**Invitation for Bid No. 2022-054**

**Chain Link Fencing Storage Area(s)**

**ADDENDUM No. 1**

**ISSUE DATE: April 22, 2022**

The Special Events Center at Jessie Helms Park  
Storage Area #1 – Left Side of Arena Looking Out

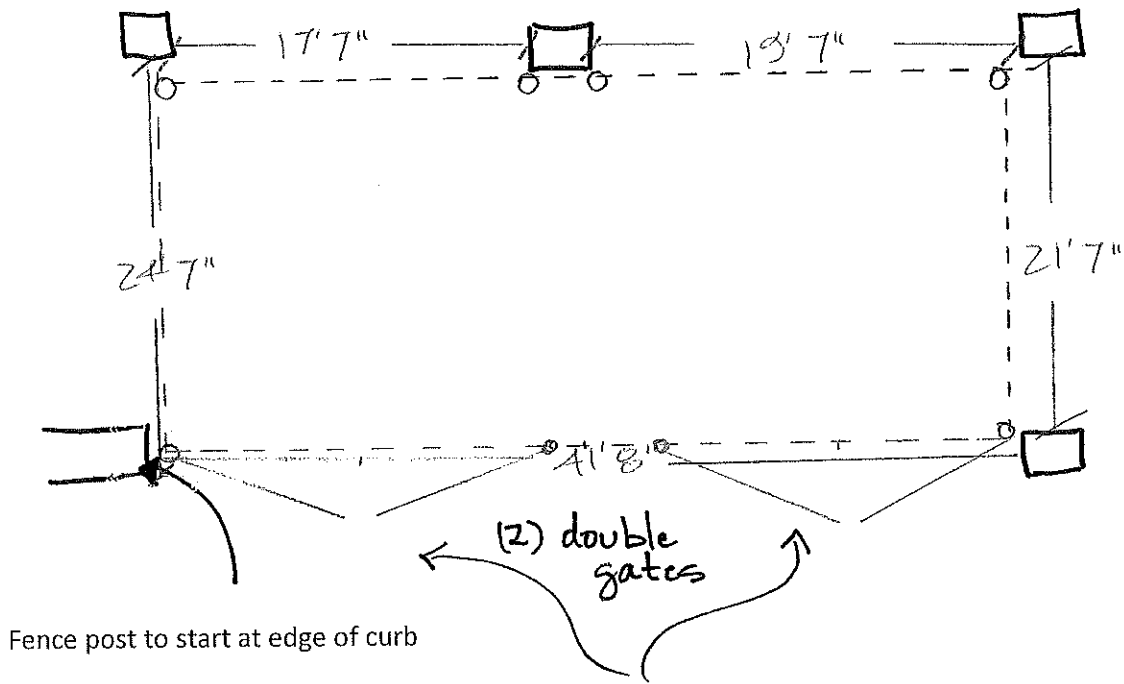
- Dimensions are shown to reflect the approximate distance between existing columns
- Fence, post and gate to be installed in concrete slab along existing control joint, shown as a dashed line -----

The Special Events Center at Jessie Helms Park  
Storage Area #2 – Right Side of Arena Looking Out

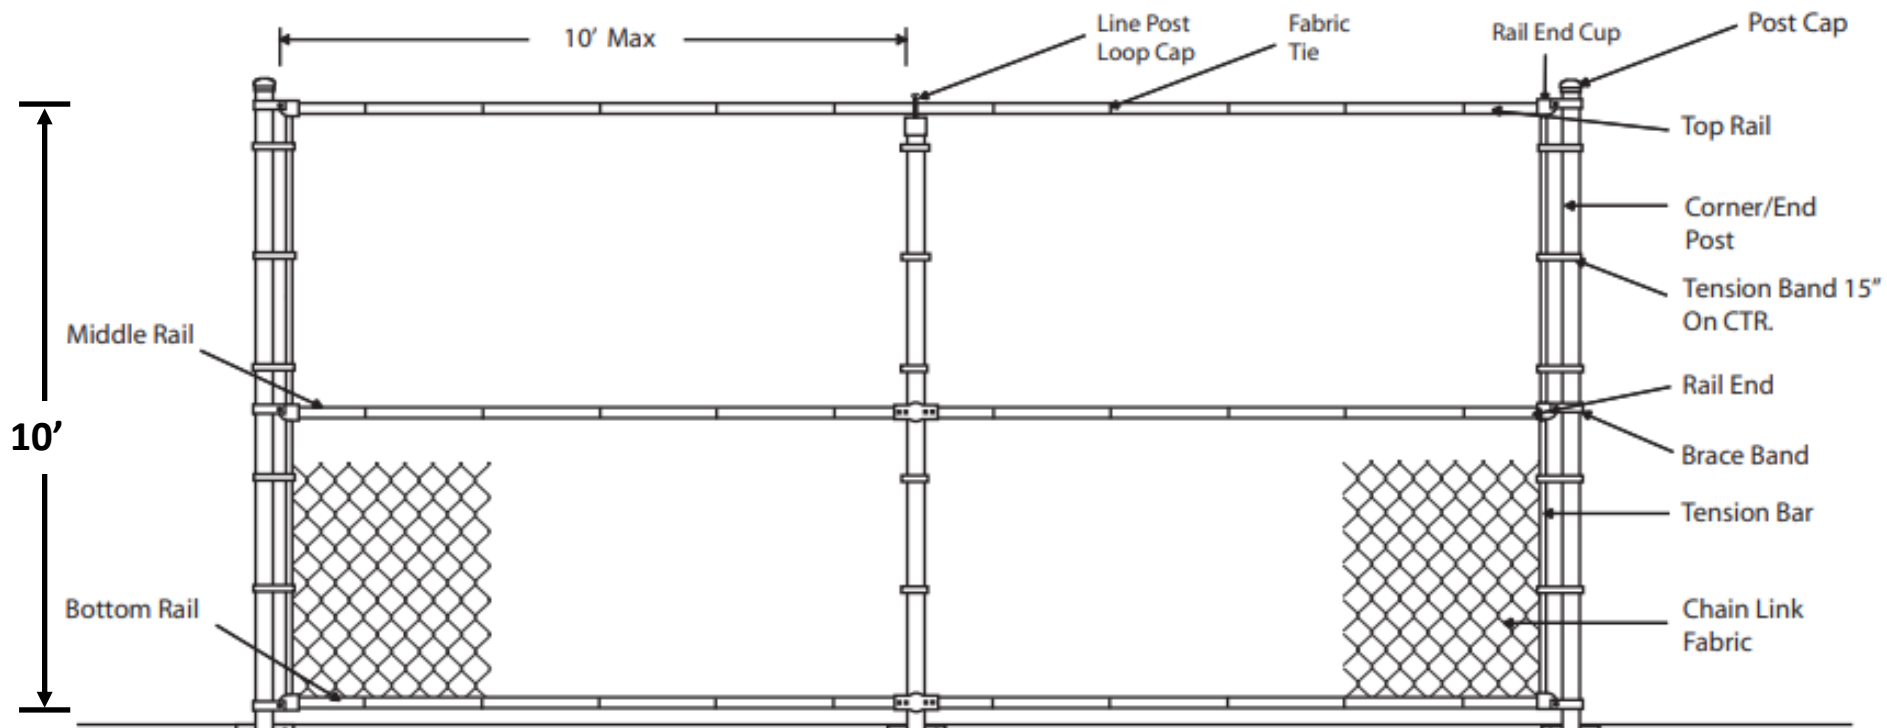
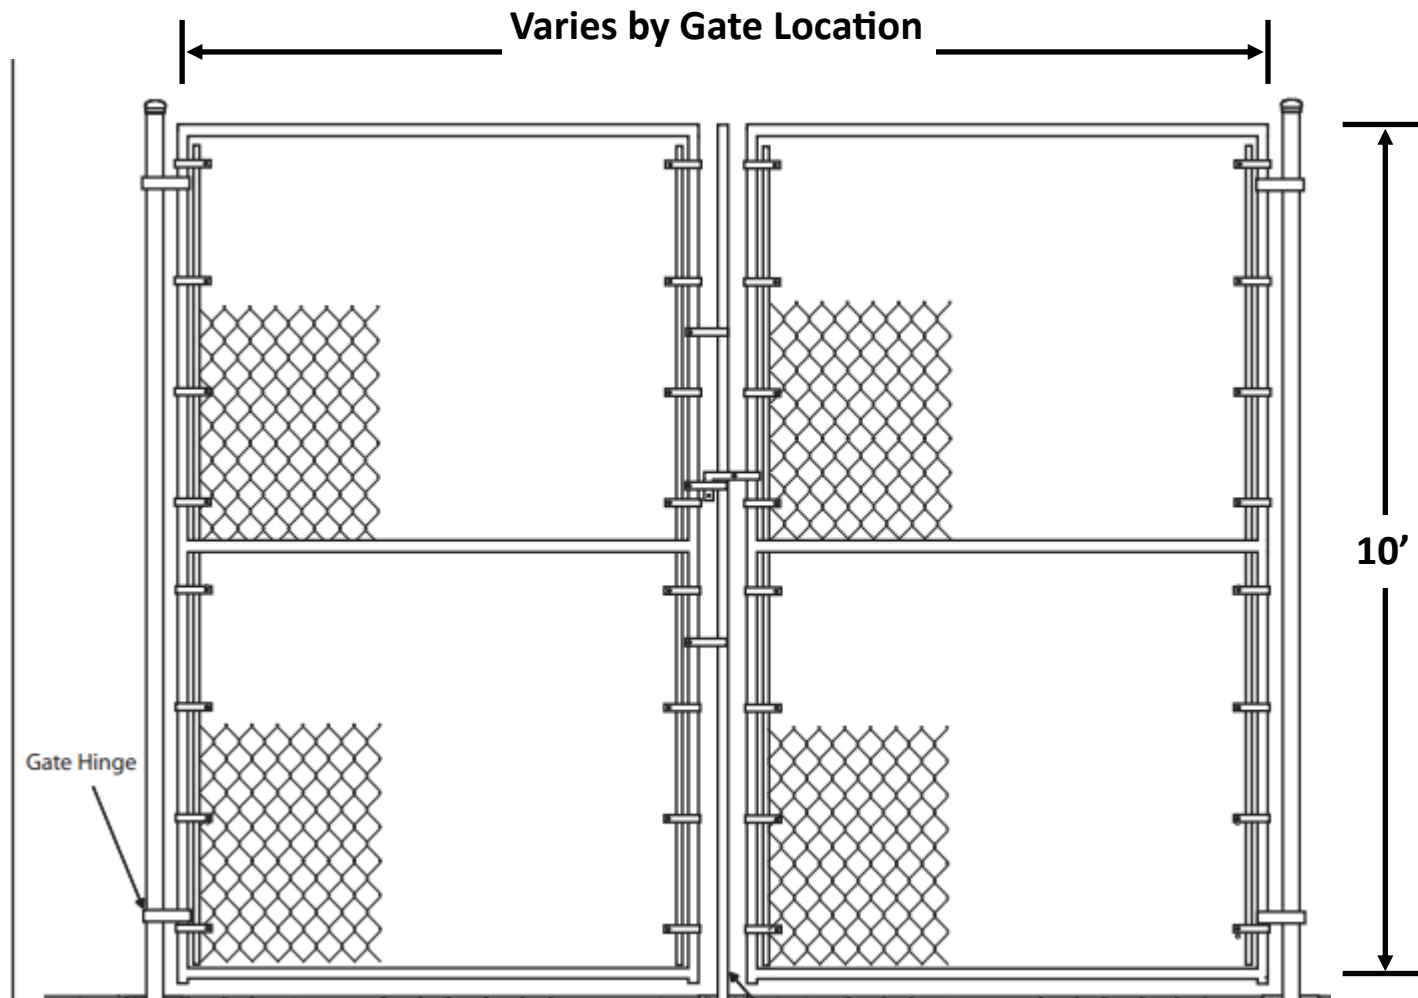
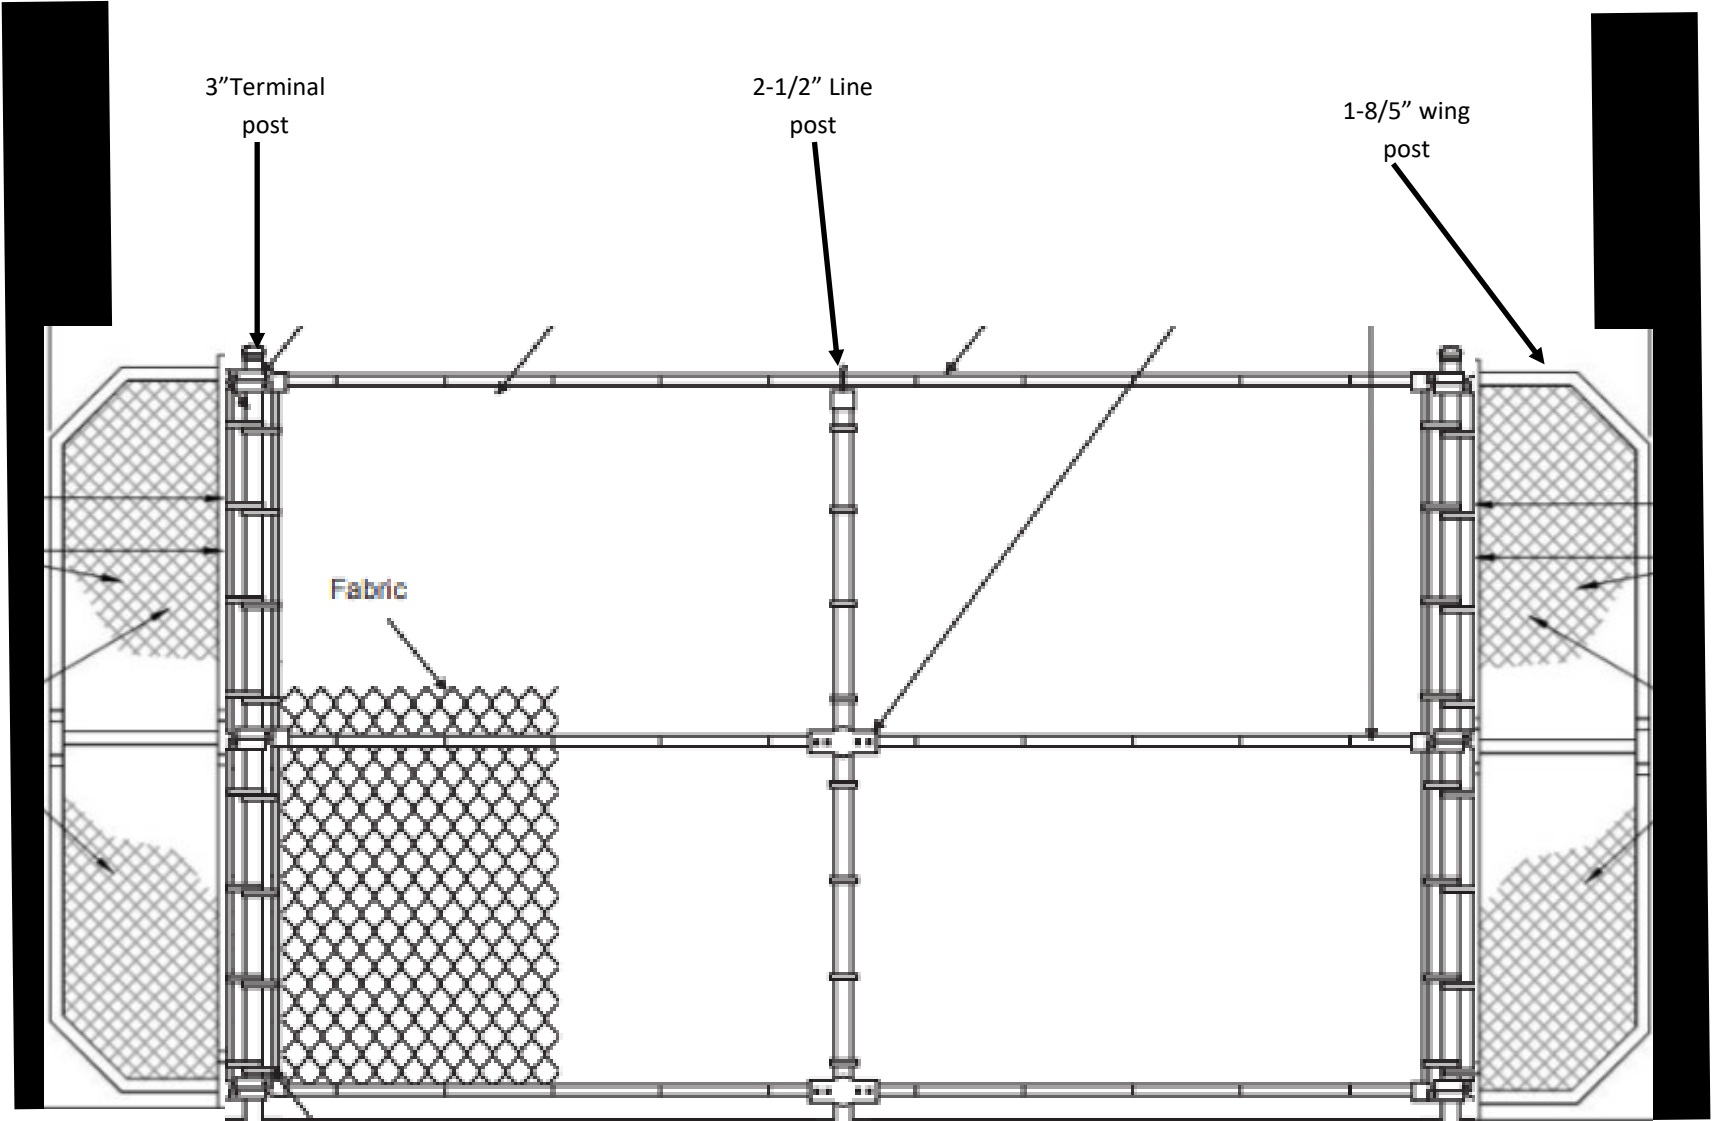
- Dimensions are shown to reflect the approximate distance between existing columns
- Fence, post and gate to be installed in concrete slab along existing control joint, shown as a dashed line -----
